24590-LAW-PCN-ENV-19-008

**Hanford Facility RCRA Permit Modification Notification Form**  
**Part III, Operating Unit 10**  
**Waste Treatment and Immobilization Plant**

Modification to the Hanford Site RCRA / WTP Dangerous Waste Permit consisting of updates to Piping and Instrumentation Diagrams for the LAW Melter Feed Process System (LFP), LAW Secondary Offgas / Vessel Vent Process System (LVP), and Radioactive Liquid Waste Disposal System (RLD). Updates performed are in accordance to WAC 173-303-830, Appendix I Modification citation number: A.3., equipment replacement or upgrading with functionality equivalent components (e.g., pipes, valves, pumps, conveyors, controls).

The purpose of this Class <sup>1</sup> modification is to provide Piping and Instrumentation Diagrams (P&IDs) for the LAW Melter Feed Process System (LFP), LAW Secondary Offgas/Vessel Vent Process System (LVP), and Radioactive Liquid Waste Disposal System (RLD) for incorporation into Appendix 9.2 of the WTP RCRA permit:

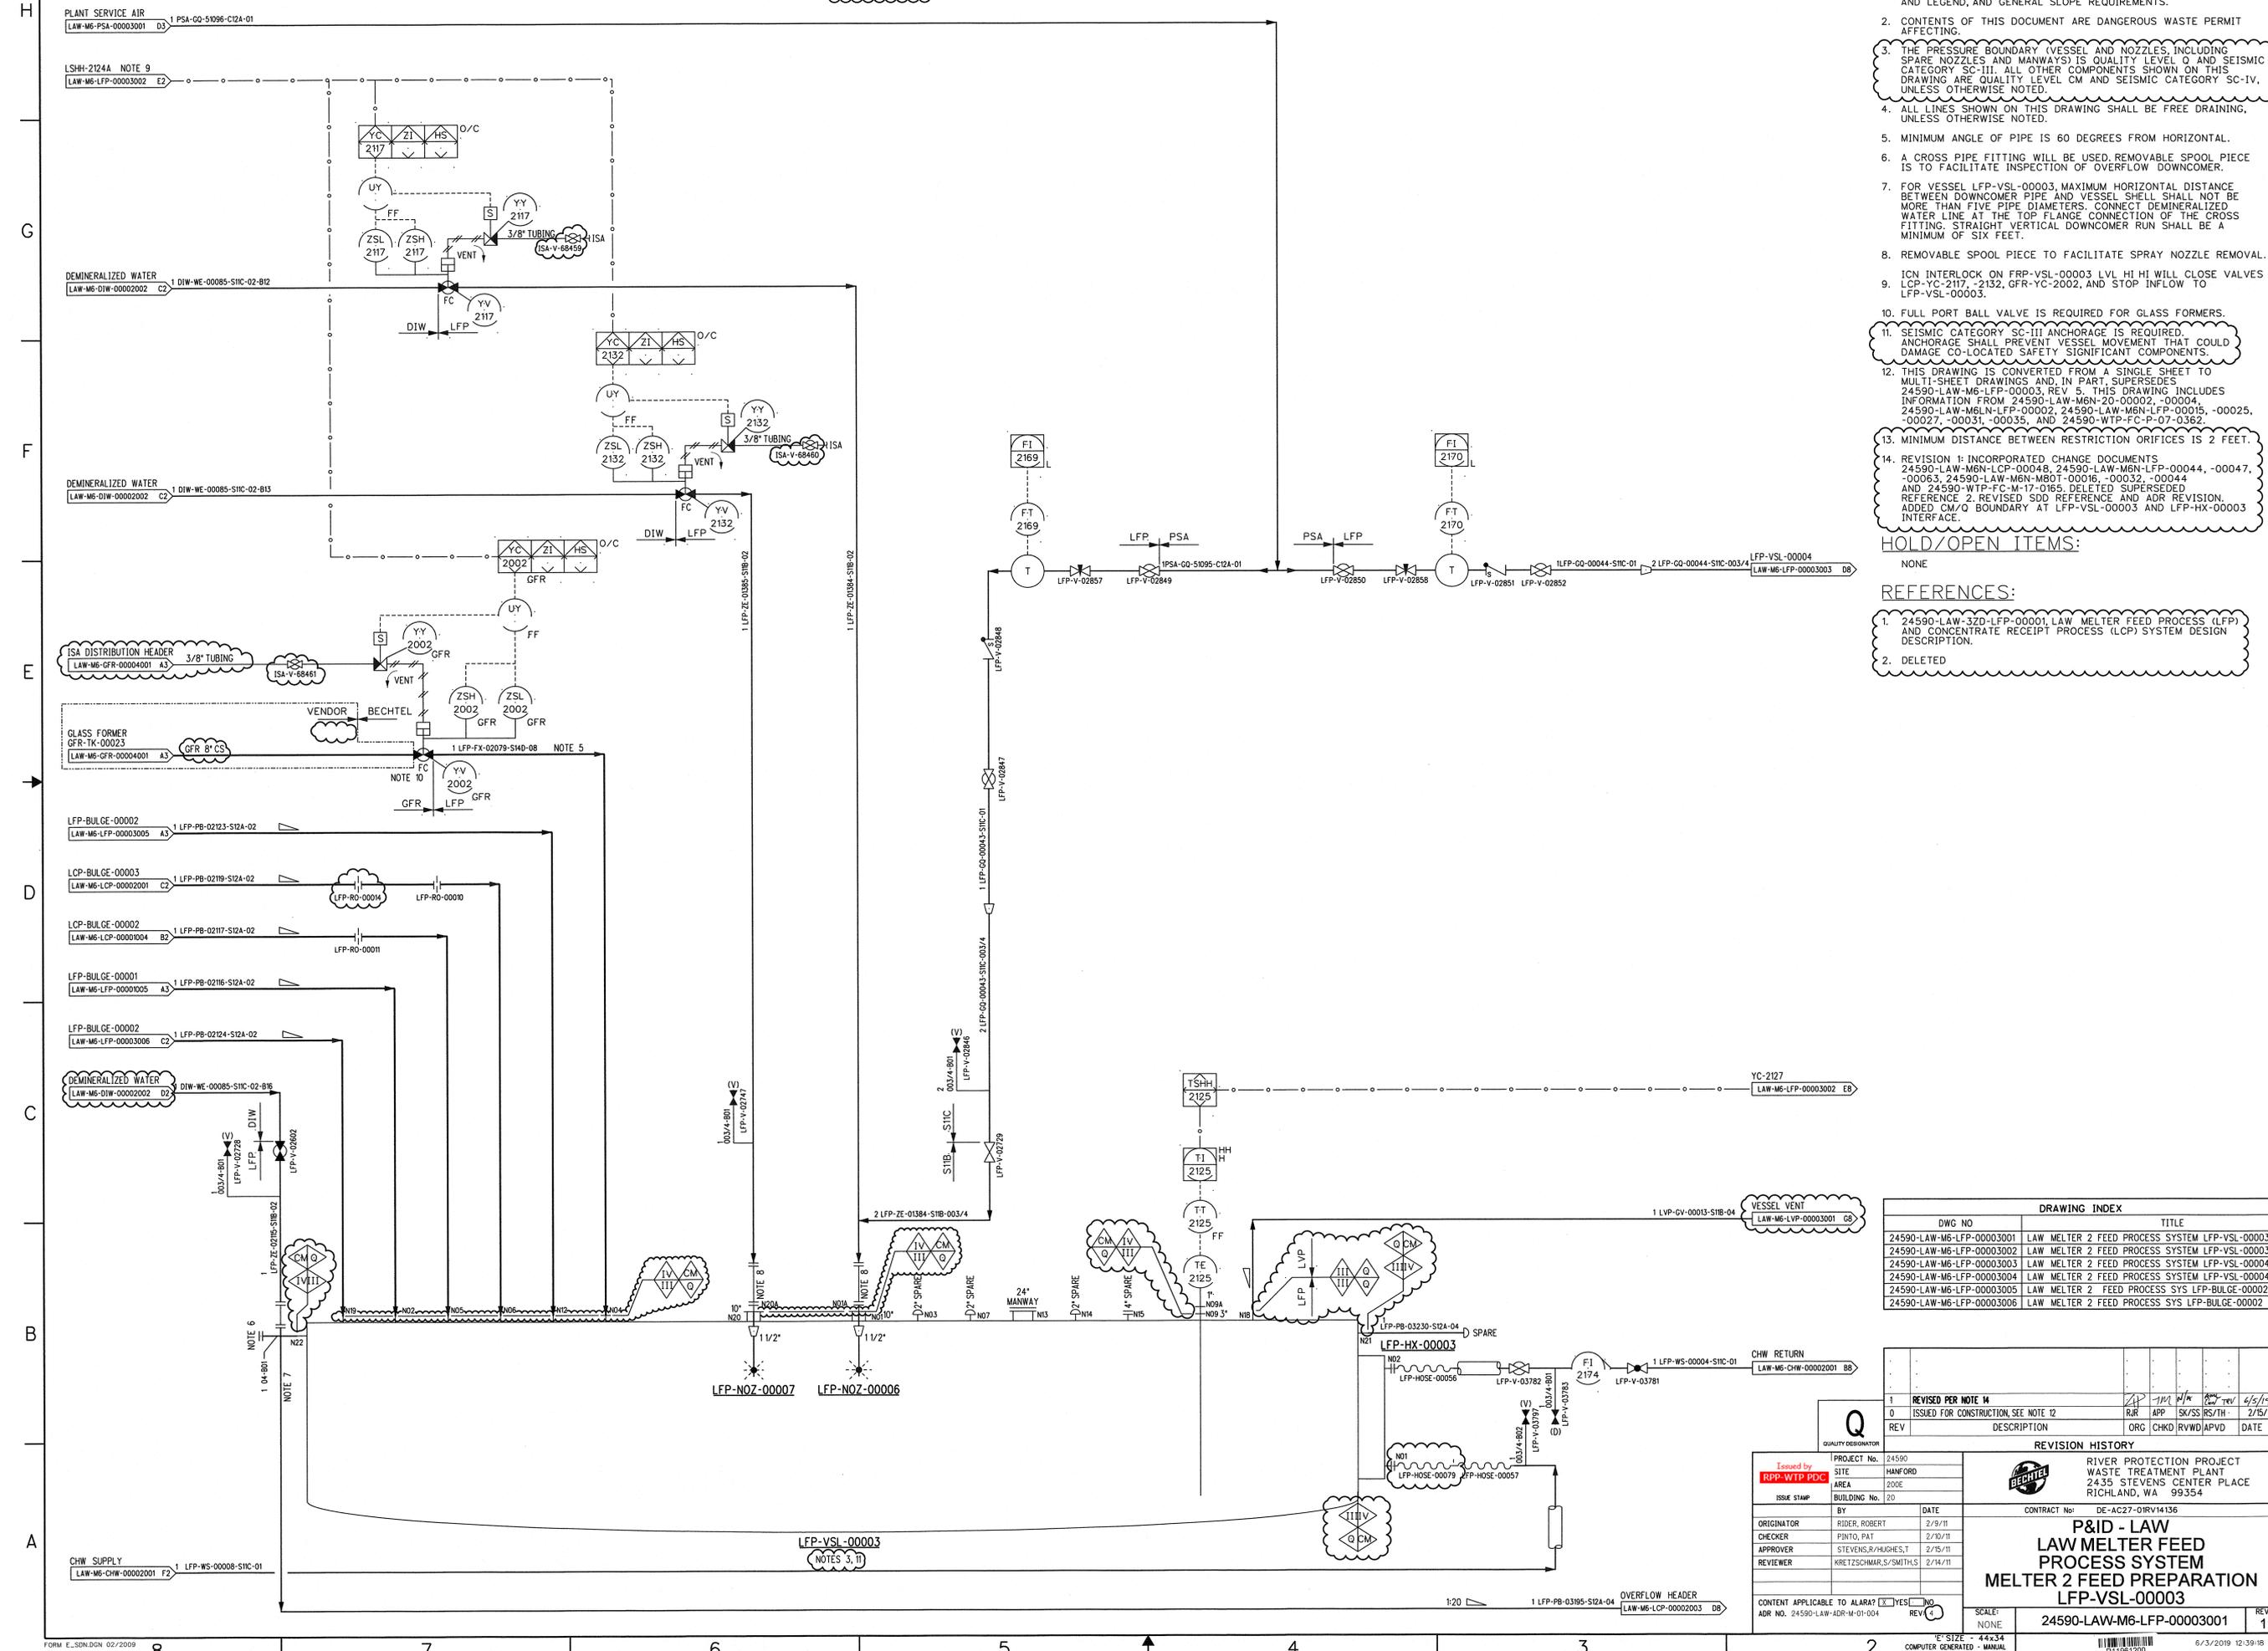
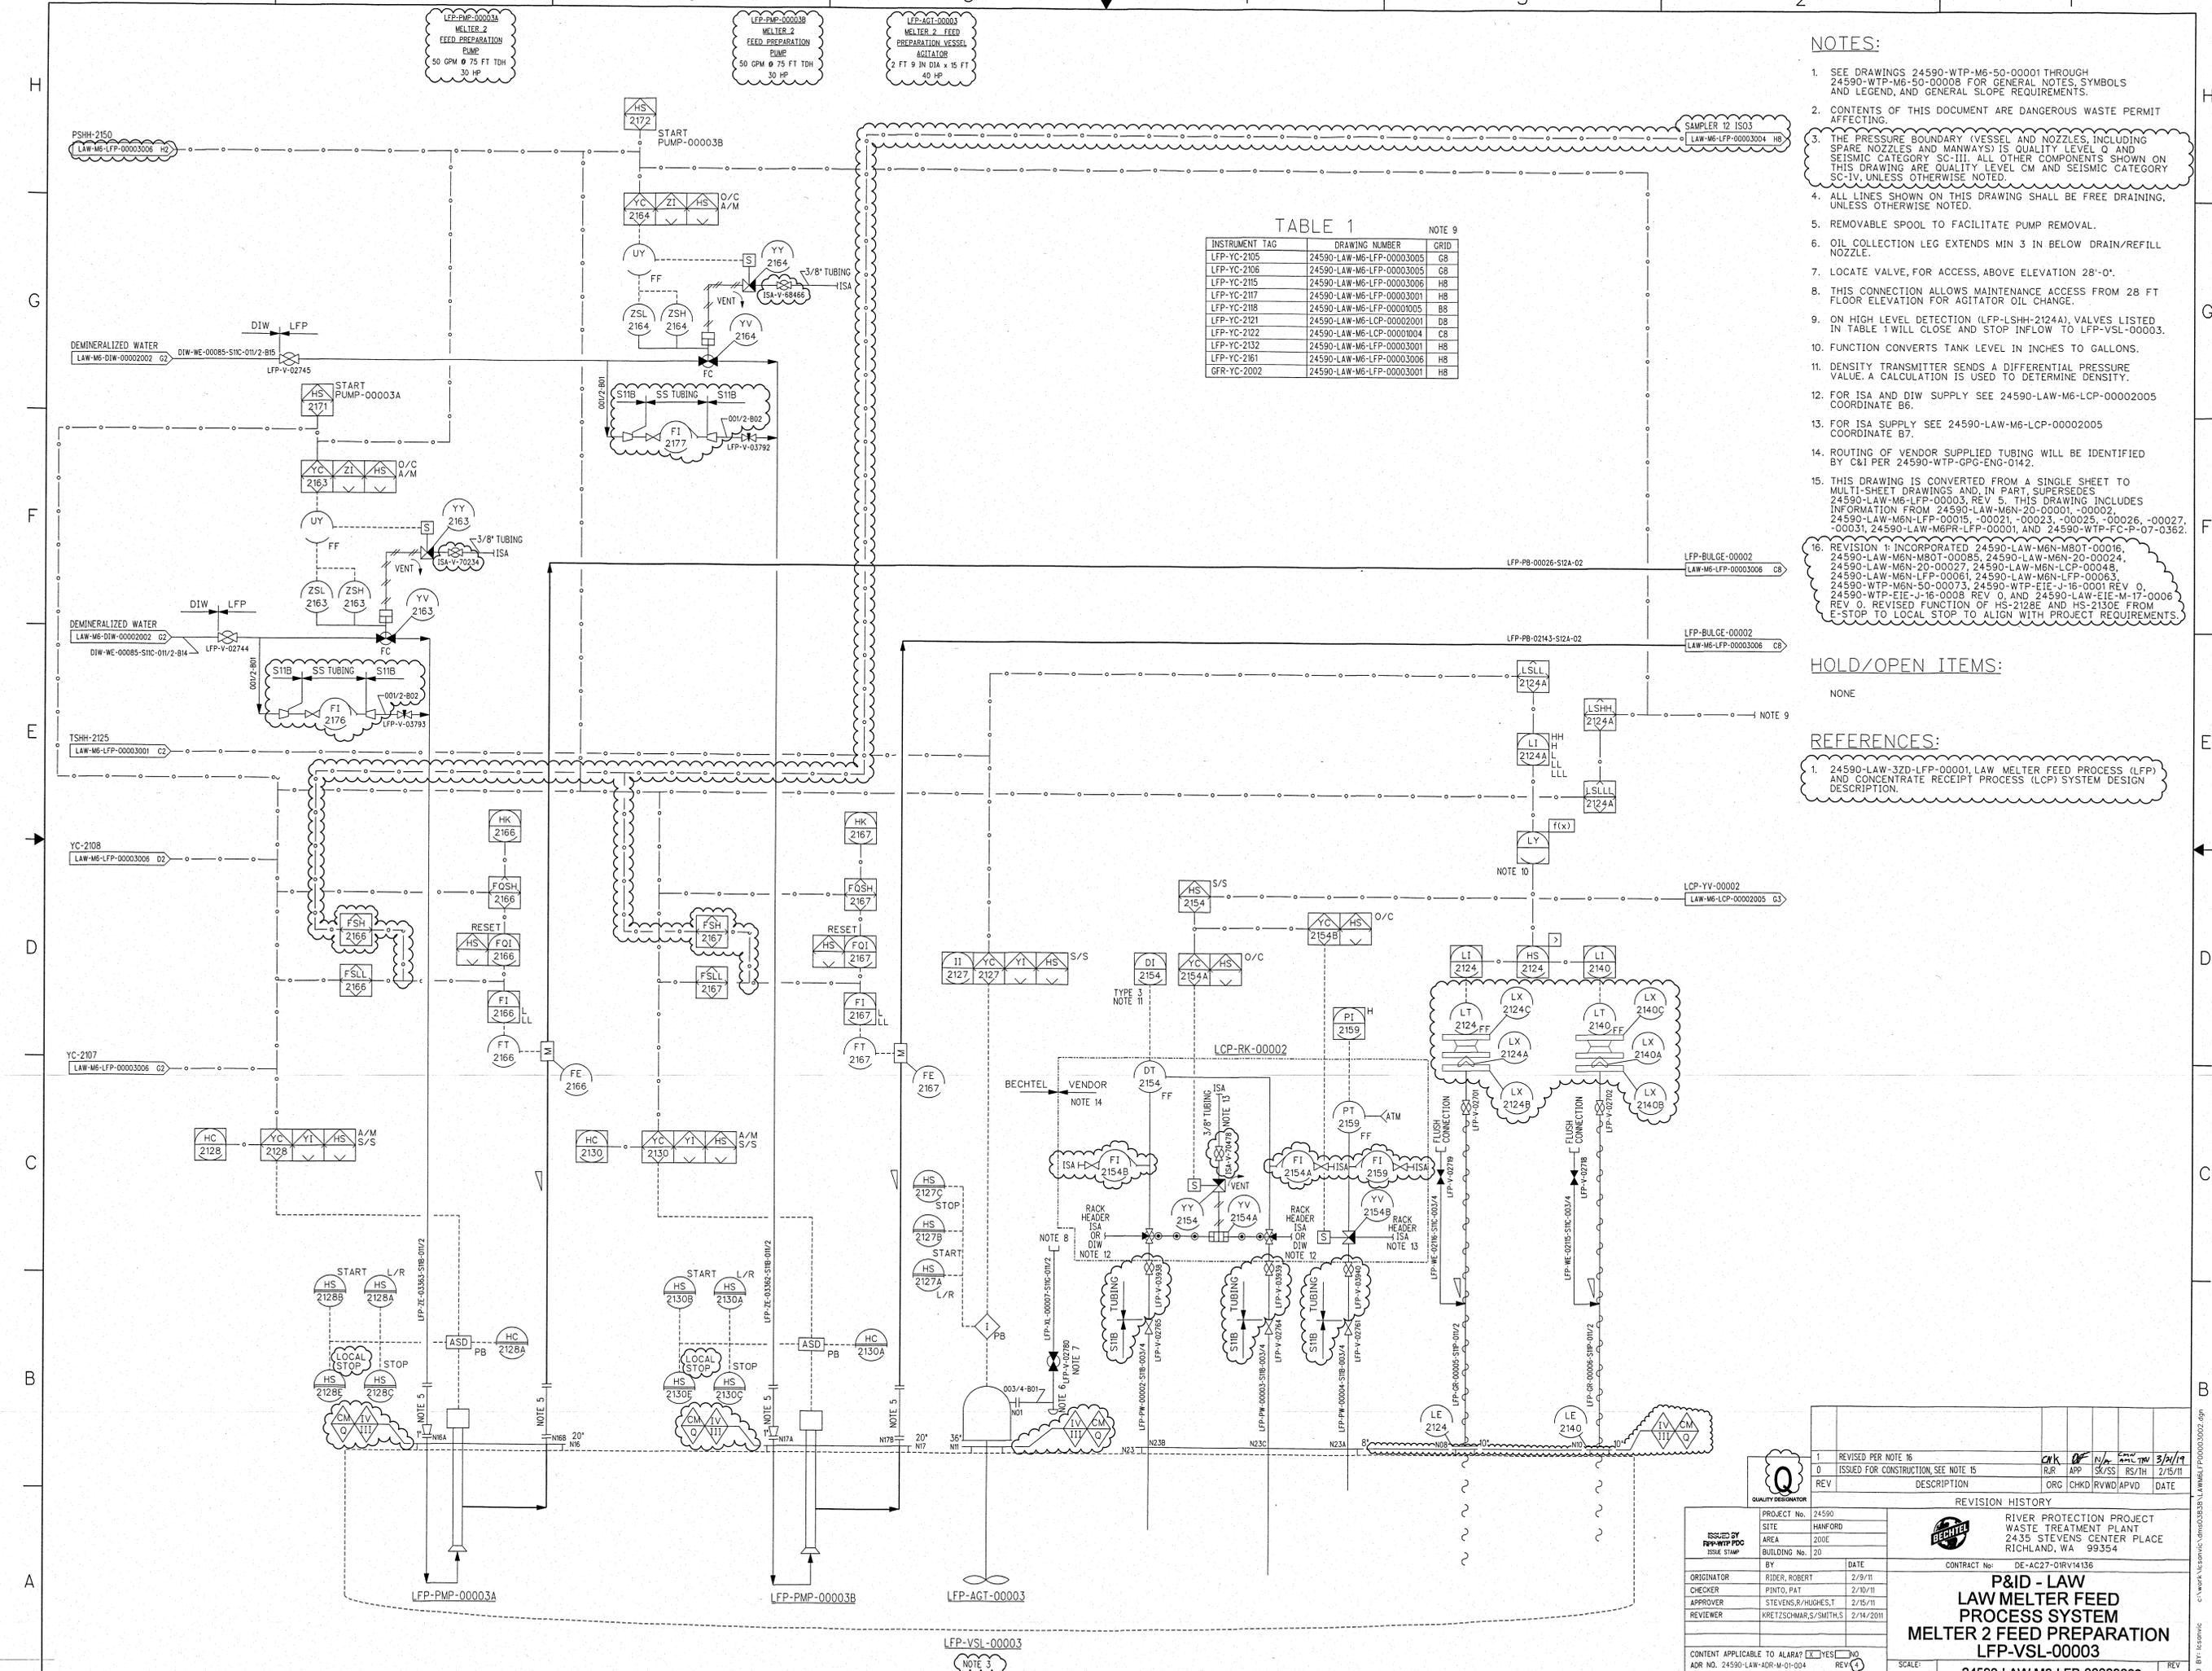
2. Significant changes incorporated into the Piping and Instrumentation Diagram (24590-LAW-M6-LFP-00003001, Rev. 1) for Melter 2 Feed Vessel LFP-VSL-00003 of the LAW Melter Feed Process System are summarized below.

- a. Addition to Note 3, quality level and seismic category of vessel, nozzles, spare nozzles and manways is specified.
  - b. Note 11 updated, unnecessary worded comparison of required seismic category of LFP-VSL-00003 to that of anchorage is removed.

- c. Addition of Note 13, stating the minimum distance between restriction orifices is 2 feet.
  - d. Addition of Note 14, Revision 1, listing of incorporated changed documents, deleted references, and revisions to references.

- e. Reference 1 updated, inclusion of LAW concentrate receipt process (LCP) system and LAW melter feed process (LFP) system design descriptions.
  - f. Deletion of Reference 2, purchase order agreement of vendor-supplied skid.

- MINIMUM DISTANCE BETWEEN RESTRICTION ORIFICES IS 2 FEET.
- REVISION 1: INCORPORATED CHANGE DOCUMENTS 24590-LAW-M6N-LCP-00048, 24590-LAW-M6N-LFP-00044, -00047, -00063, 24590-LAW-M6N-M80T-00016, -00032, -00044 AND 24590-WTP-FC-M-17-0165. DELETED SUPERSEDED REFERENCE 2. REVISED SDO REFERENCE AND ADR REVISION. ADDED CM/O BOUNDARY AT LFP-VSL-00003 AND LFP-HX-00003 INTERFACE.
